METROPOLITAN GOVERNMENT OF NASHVILLE AND DAVIDSON COUNTY

STAFF RECOMMENDATION 2402 Belmont Boulevard April 15, 2015

Application: New construction-addition and outbuilding; Setback determination
District: Belmont-Hillsboro Neighborhood Conservation Zoning Overlay
Council District: 18
Map and Parcel Number: 10416039000
Applicant: Kaitlyn Smous, Allard Ward Architects, LLC
Project Lead: Paul Hoffman, paul.hoffman@nashville.gov

Description of Project: An application for a ridge raise, rear dormer, and a rear addition to the house, and a detached outbuilding, that is not to be used as a dwelling unit. The house itself is only four feet (4') from the property line; as the addition will match the width of the house, a setback determination from five feet (5') to four feet (4') is requested.

Site Plan

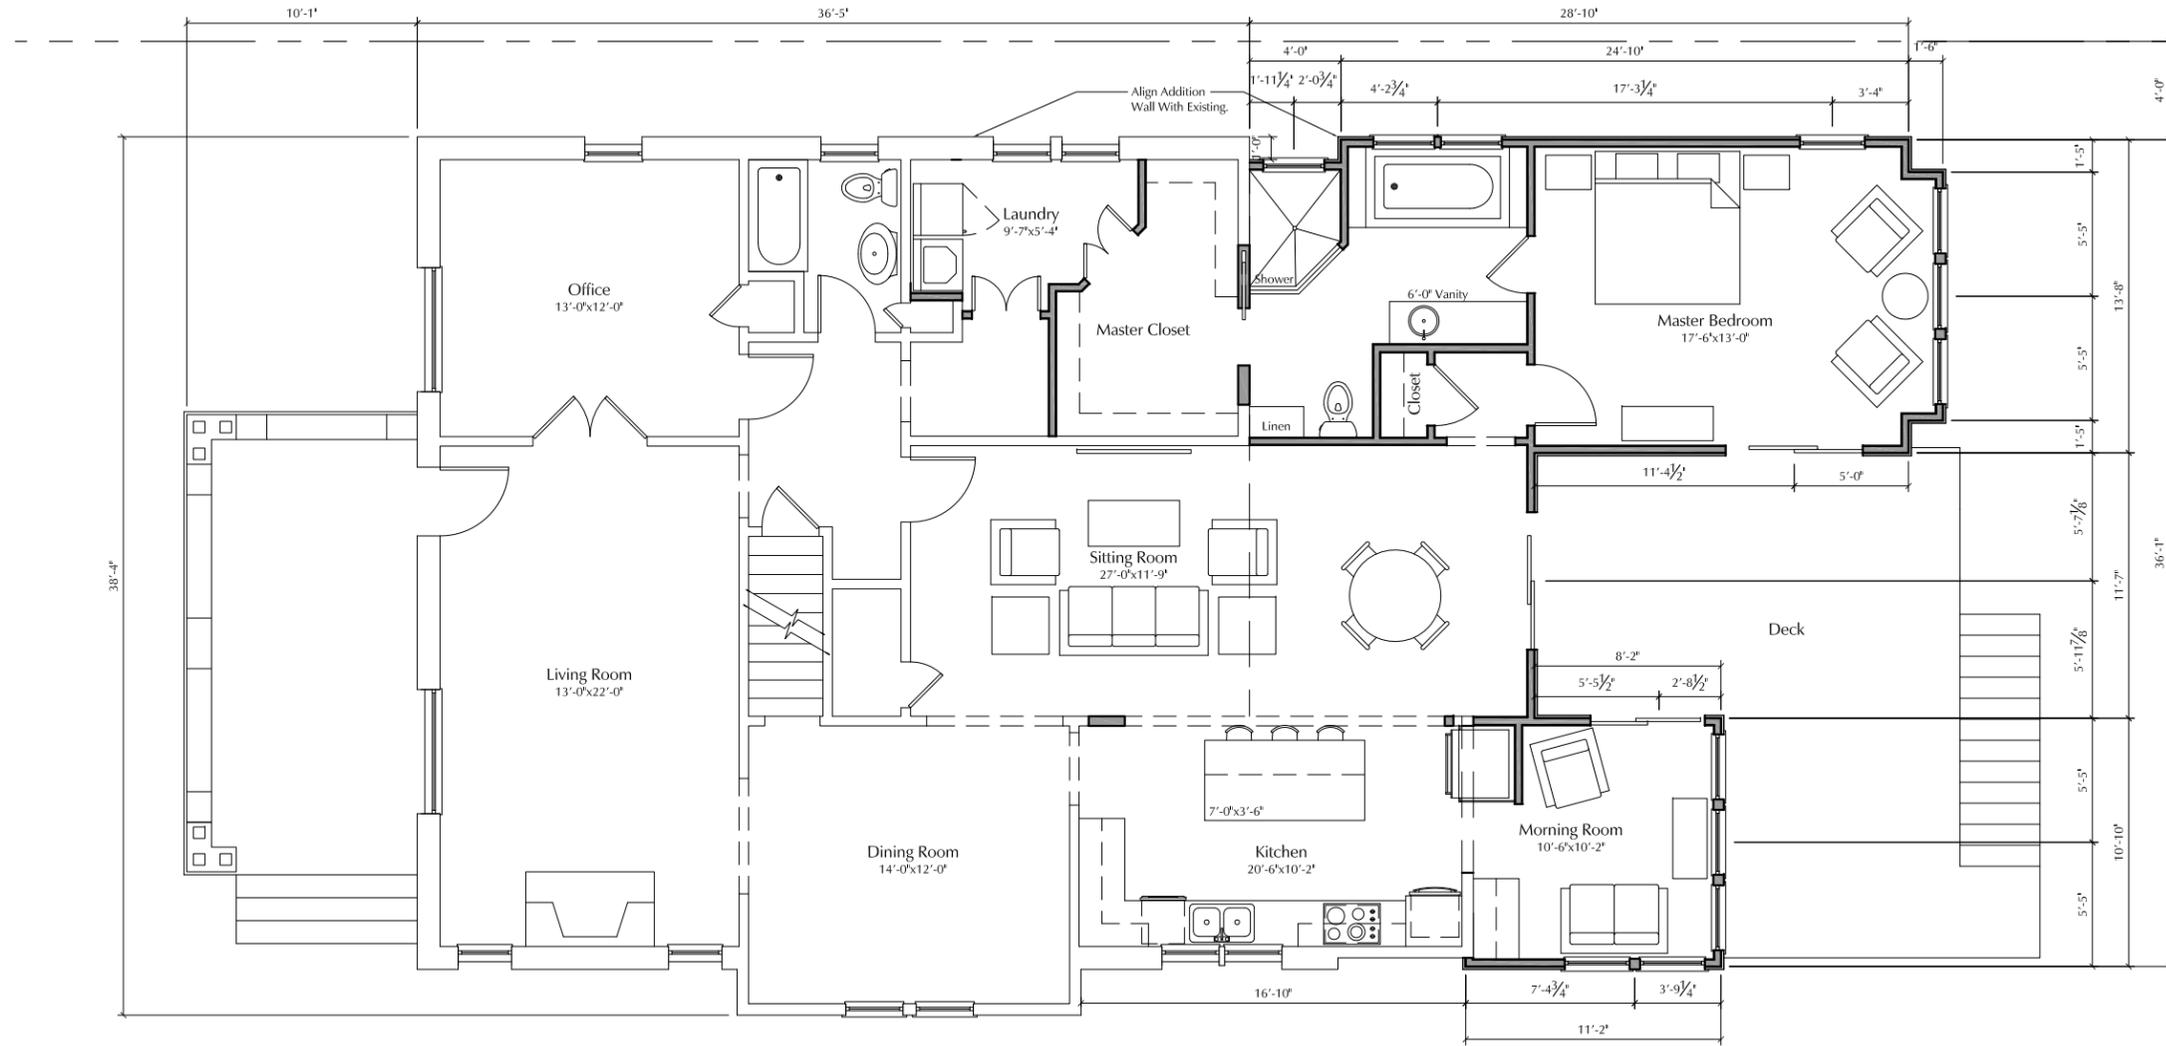
Setback: The side setbacks of the addition will be four feet (4') on the left and twenty-two feet (22') on the right. On the left side, the house currently encroaches into the setback area by one foot (1'). The addition will match the width of the house on that side. As this is an existing condition, and the addition is not going to be wider than the house, Staff finds the requested setback appropriate. The rear setback will be fifty-three feet (53'), which meets the required twenty feet (20'). The project meets section II.B.1.c.

Drawings:
 West Elevation
 North Elevation
 Date:
 03.30.15

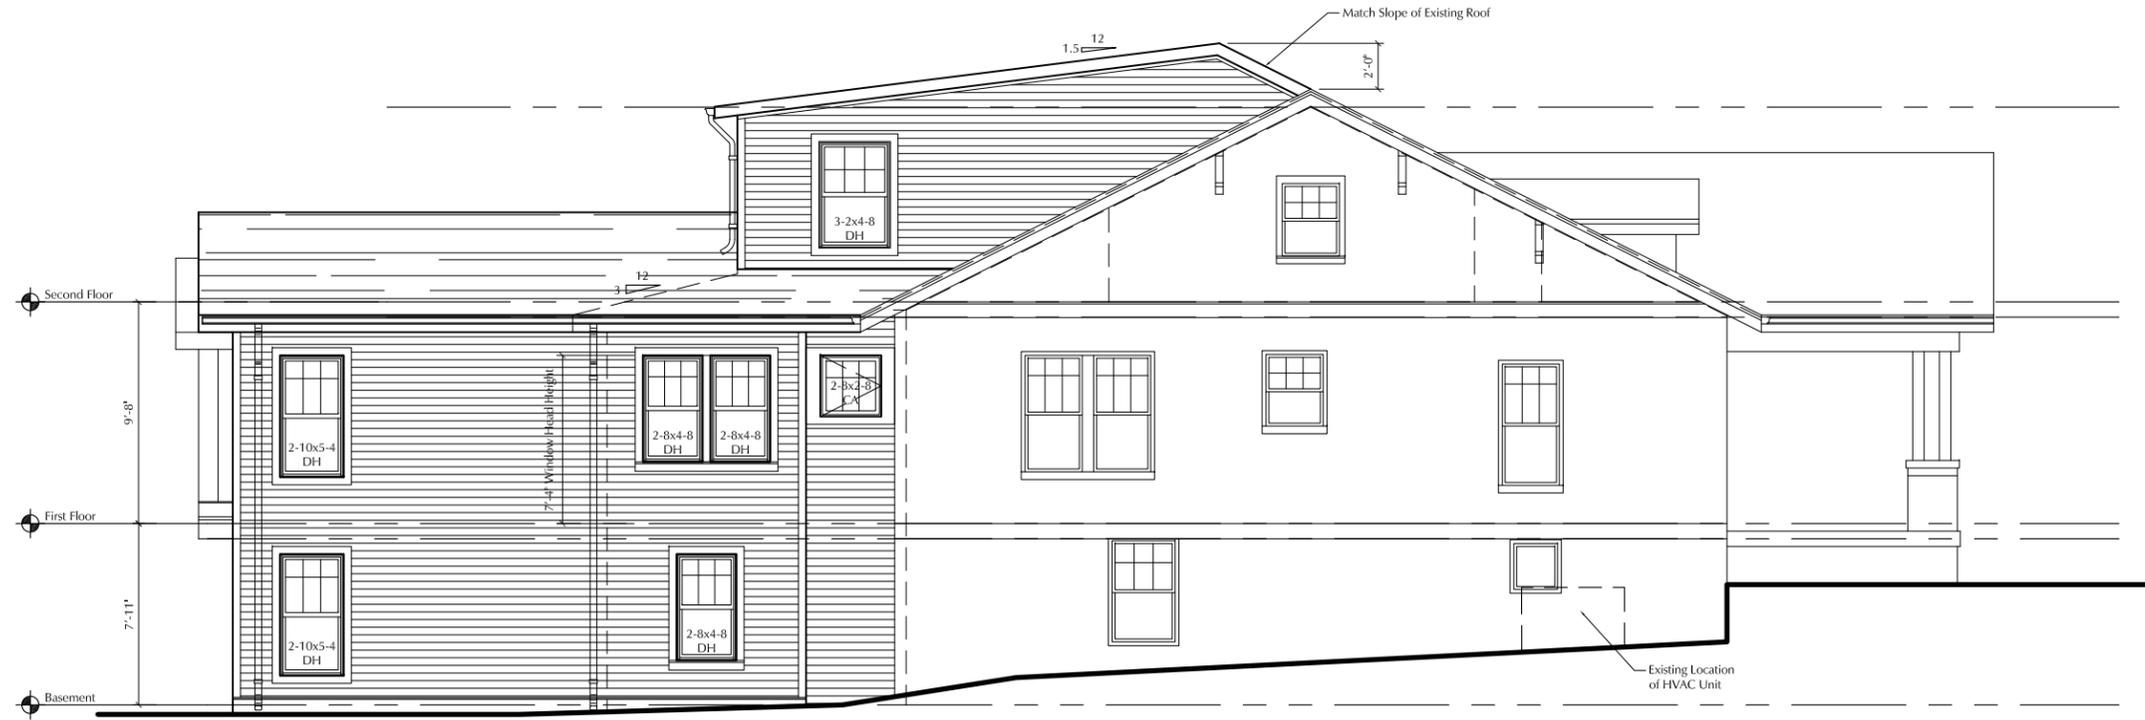
Proportion and Rhythm of Openings: No changes to the window and door openings on the existing house were indicated on the plans. The windows on the addition are generally twice as tall as they are wide, meeting the historic proportion of openings. The largest expanse of wall space without a window or door opening is twelve feet (12')

between windows on the north elevation. Staff finds the project's proportion and rhythm of openings to meet Section II.B.1.g.

Drawings:
 Garage Elevations
 Date:
 03.30.15

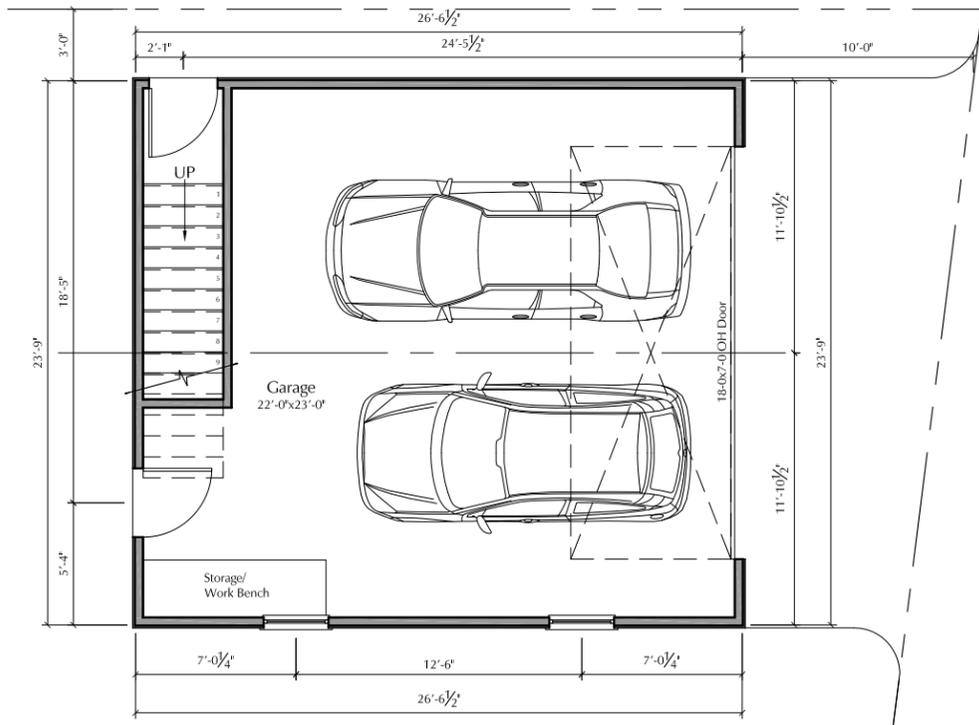
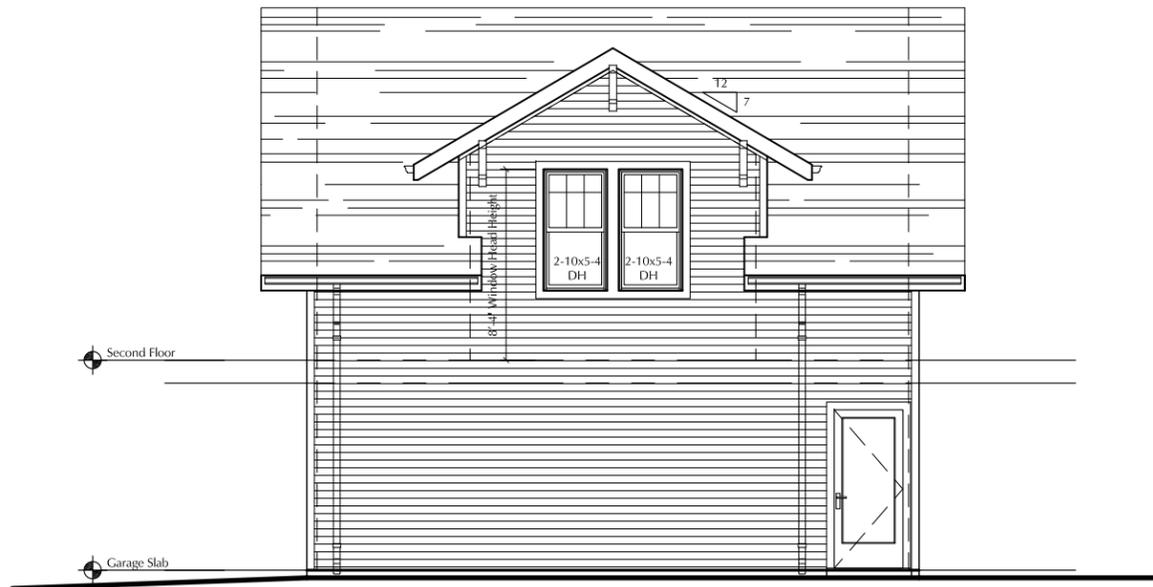
Outbuildings: The proposed outbuilding will be twenty-seven feet by twenty-four feet (27' x 24') for a footprint of six hundred and forty-eight square feet (648 sq. ft.) and approximately twenty-five feet (25') tall. It will have a garage on the ground floor and studio space on the second floor. The materials include fiber cement siding, wood trim, and similar windows to the addition. See outbuilding worksheet for complete evaluation. It meets the design guidelines with three exceptions:

1. Dormers: Wall dormers are atypical historically, but the outbuilding is not a detached accessory dwelling unit (DADU), and this location will have minimal visibility from the street.
2. Eave height: although the design guidelines ask for an eave height no taller than ten feet (10'), as the outbuilding has a smaller footprint than is required, and will not be highly visible in its location on the alley, Staff finds the proposed design acceptable.
3. Location: At eighteen feet, five inches (18'5") the outbuilding will be less than twenty feet (20') from the new addition to the house. However, moving the outbuilding more to the rear would further encroach on the rear setback.

Staff recommends approval of the project with the condition that Staff has final review of the windows, doors and garage doors.
